MONTGOMERY COUNTY HISTORIC PRESERVATION COMMISSION
STAFF REPORT

Address:	10201 Menlo Ave.	Meeting Date:	1/10/18
Resource:	Contributing Resource Capitol View Historic District	Report Date:	1/3/18
Review:	HAWP	Public Notice:	12/28/17
Case Number:	37/07-17G (continued)	Tax Credit:	None
Applicant:	Minter Farnsworth	Staff:	Dan Bruechert
Proposal:	New Construction

Staff recommends that the HPC **approve with two (2) conditions** the HAWP application.

TREE SURVEY
1" = 20'

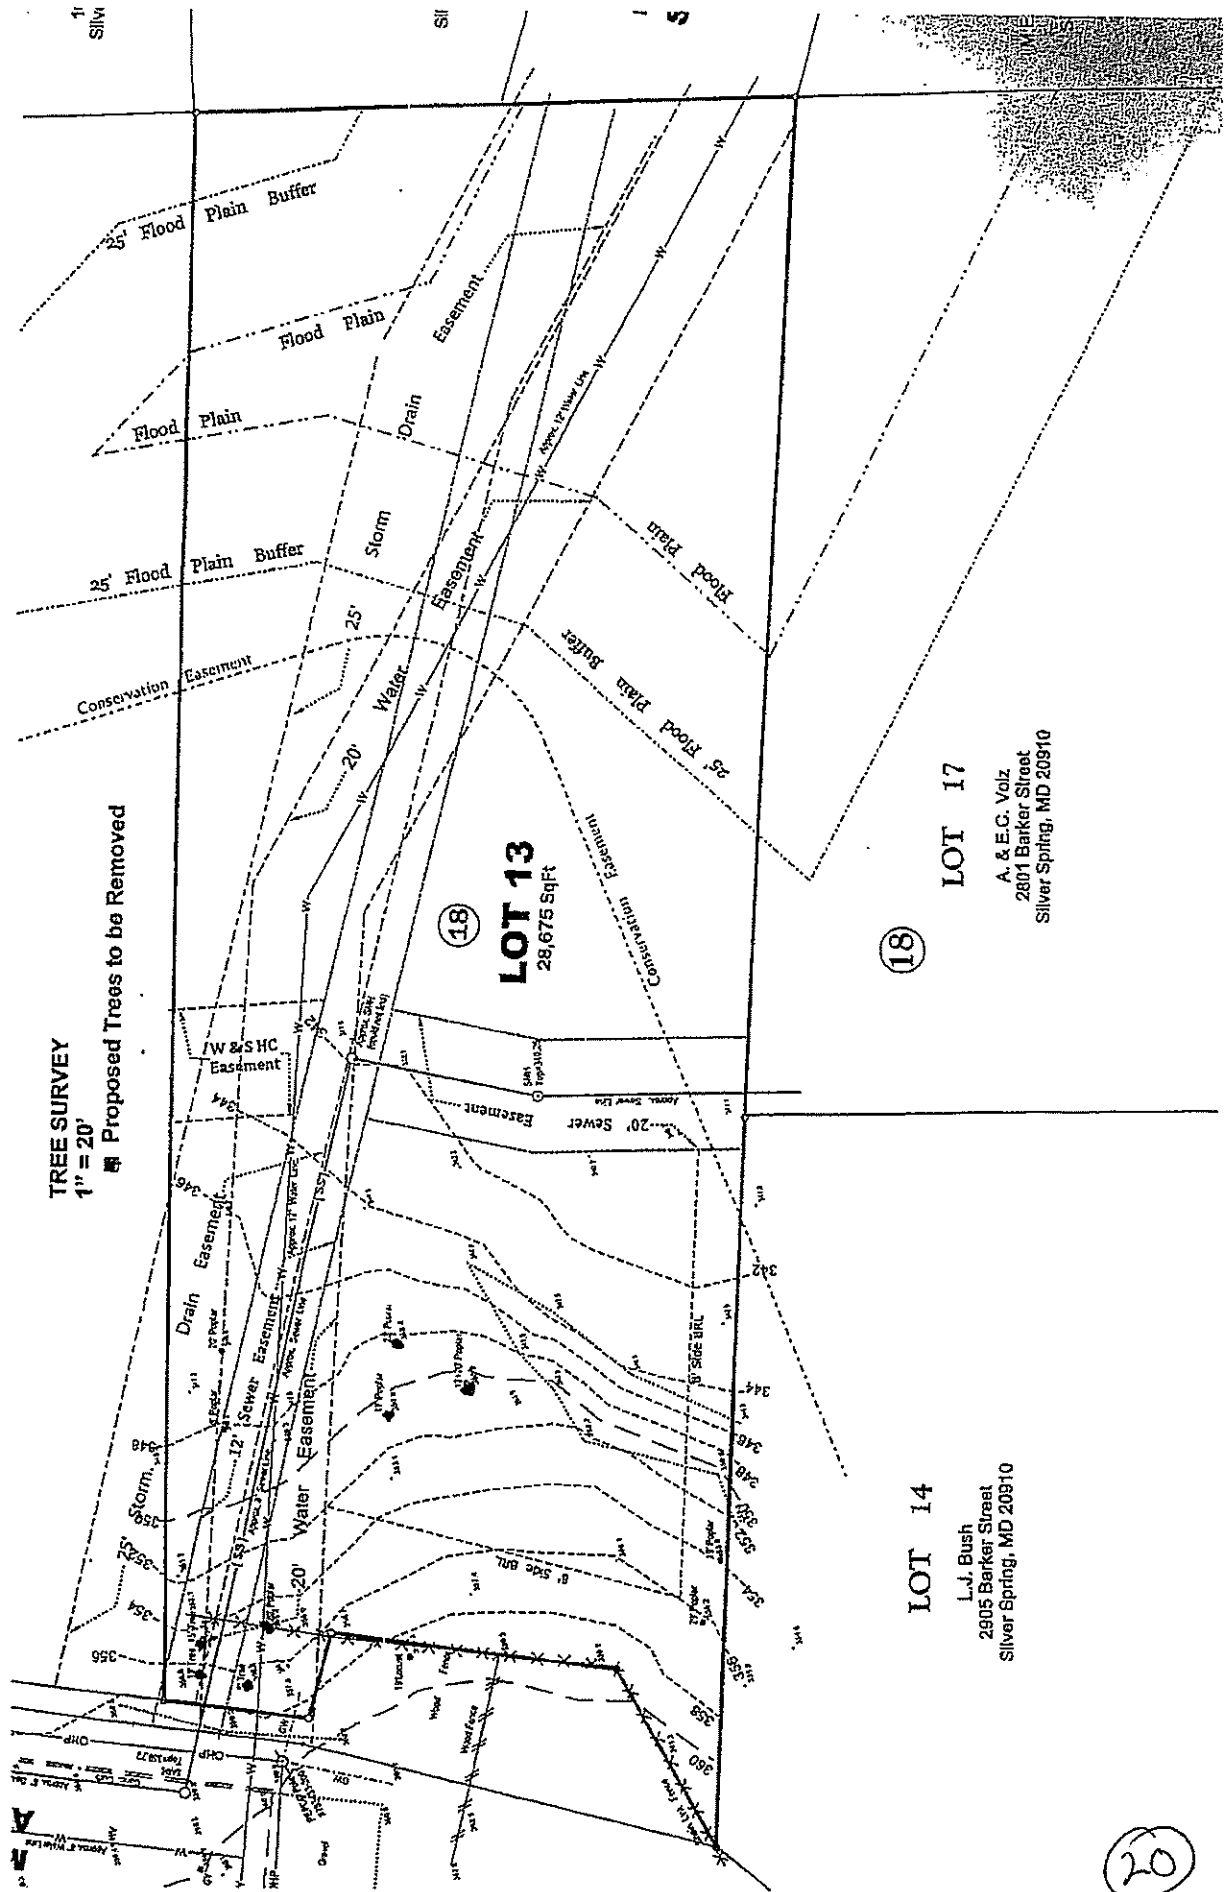
The applicant has identified a total of nine trees with trunks larger than 6" (six inches) d.b.h. proposed for removal (see the attached Tree Survey). Bartlett Tree Experts conducted a survey of the lot (see Circle ____). Four trees are at the edge of the property and are located at the only access point from the property to the public streets. Three trees are located in the center of the proposed house construction, which the survey shows are about the only place where construction can occur on this site. There are two additional tulip poplars along the right property line. Both of these trees will be impacted by the construction and are recommended for approval. Due to the unique lot placement and the slope of the lot, the driveway and house could not be placed anywhere else on the site. Staff feels that the loss of these trees is unavoidable and recommends approval for their removal. To deny the tree removal would deprive the owner of reasonable use of the property as zoning currently allows this lot to be developed with a single-family home (24A-8(b)(5)). The applicant also is required to plant nine (9) additional trees on the site or pay a fee in lieu of planting as part of the County's Tree Canopy Conservation Law.

1. The proposed windows must be either wood or clad. Details need to be submitted to Staff for review and approval with final approval authority delegated to staff.
2. Placement and species of the new trees needs to be submitted with permit drawings for review and approval with final approval authority delegated to Staff.
